**Hill of Fare Windfarm Information Group
(HOFWIG)**

**Response to
Additional Information Report (AIR)
Issued by RES**

September 2024

Figure 5.1: PWS infrastructure layout detail in East (taken from Figure 2.2, AIR Appendix 1)

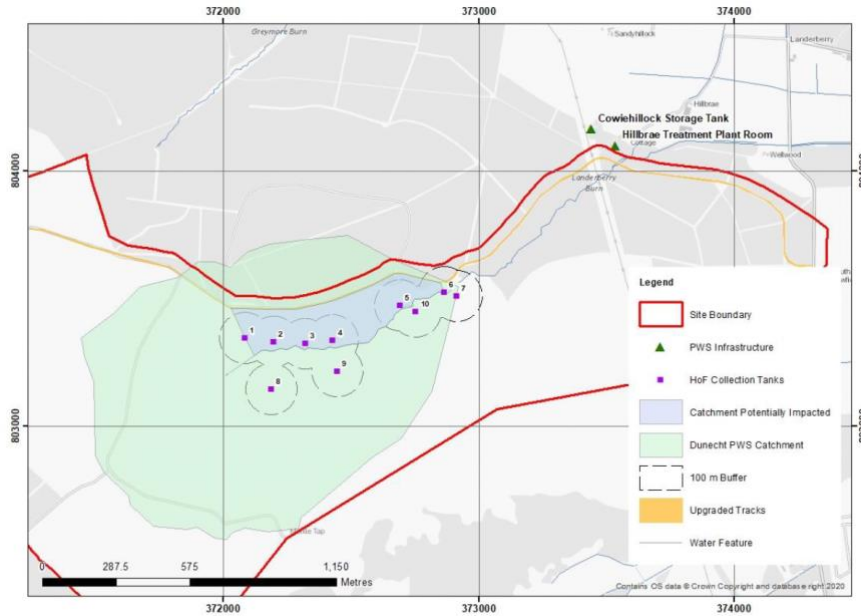
Fig 5.1 shows the PWS infrastructure layout in the East of the site, highlighting the Dunecht catchment area in light green, as well as the HOF collection tanks and 100m buffer zones referred to by SEPA. The AIR has assessed the impact of the upgraded access track to the north of the collection tanks only.

The long-term hydrological impacts of tracks on peatlands, particularly “floating” tracks, and the resulting carbon loss due to drainage effects are unknown (IUCN, 2016). Tracks may impound or divert water flow, potentially resulting in waterlogging on one side of the track and drying on the other. ([SNH, Constructed Tracks in the Scottish Highlands, 2015](#), NatureScot, Constructed Tracks in the Scottish Uplands, 2013 – link currently down!).

Figure 5.2: Infrastructure layout (taken from Figure 1.2, EIAR Volume 2)

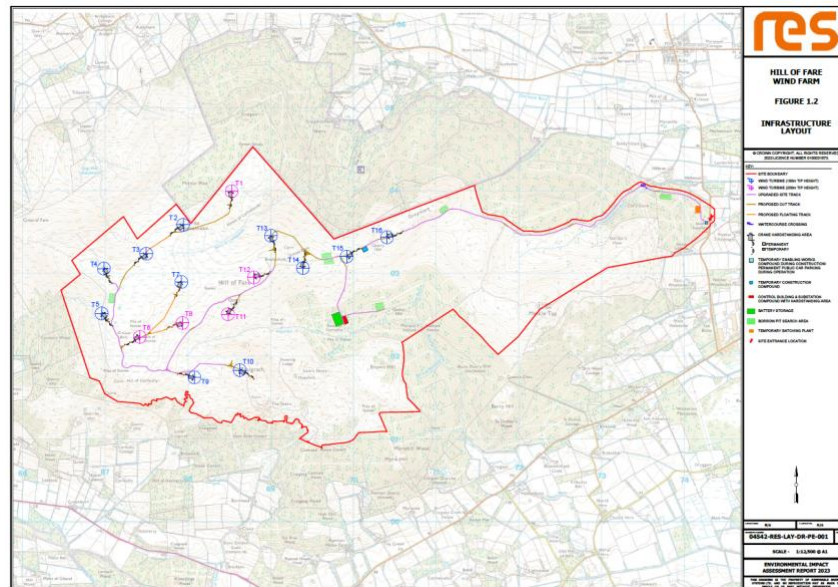
Furthermore, the development comprises a total of 7.3km of new track construction and 10.3km of upgrades to existing tracks (see Figure 5.2).

Access tracks are planned to be 4.5m wide though there will be some abnormal load turning heads built, which will be wider. Most tracks will be excavated, but where peat depths are >1m, they will be “floated” over the peat (e.g., between T6-T7 and T6-T8). Some will also be “cut” (e.g., between T13-T14-T15).

No assessment has been made of the impact of 17.6km of 4.5m wide tracks shown in Figure 5.2 on the catchment areas shown in Figure 5.3. These including some “floating” tracks on deep peat. The risks are unknown which is not acceptable in an area of PWS.

Figure 5.3: PWS infrastructure (taken from Figure 10.7, EIAR Volume 2)

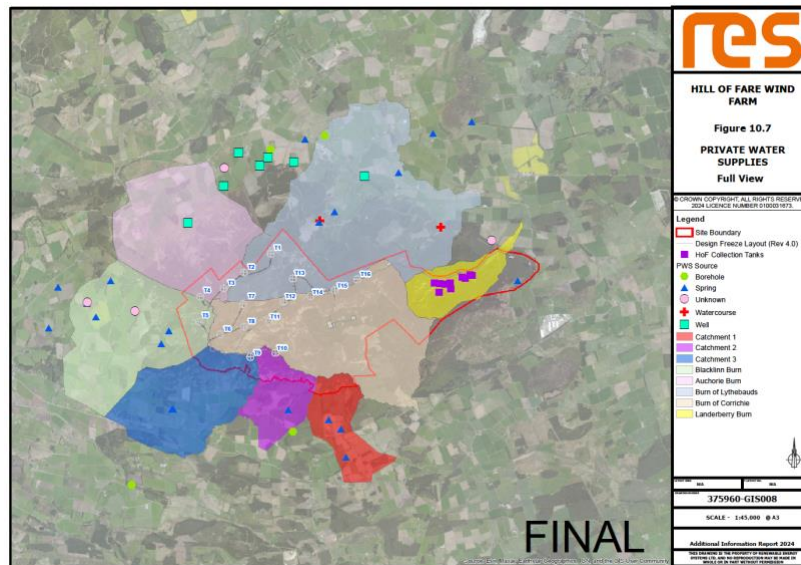
Figure 5.3 shows the PWS infrastructure with a total of 8 catchment areas. The HOF collection tanks in Figure 5.1 are located to the East of the site and are highlighted in purple.
